MAS003652 RU 23-29

Rapid Update 642 GranTurismo – Light Bar Bezel Replacement

DATE: JULY 12 2023

Certain Maserati GranTurismo (189) MY24 listed in MODISCS+ are involved in a Rapid Update to replace the license plate lamp moulding.

Overview

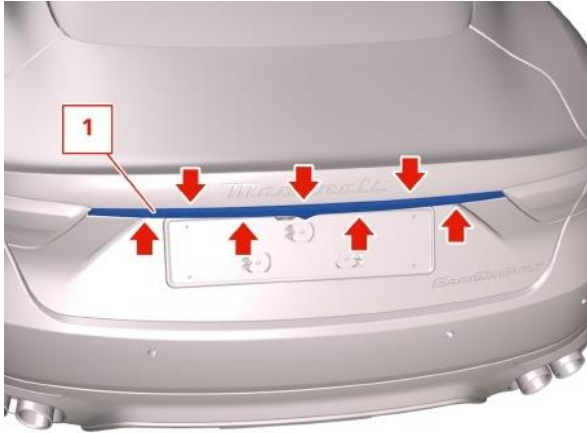
This action is needed due to the **old black-painted** moulding could be affected by detachment in case of thermal stress (heavy sun exposure, parking in hot area, etc..).

The **new** component, instead, have a **black-chrome finishing** that do not present the same defects giving a more luxury feeling to the car.
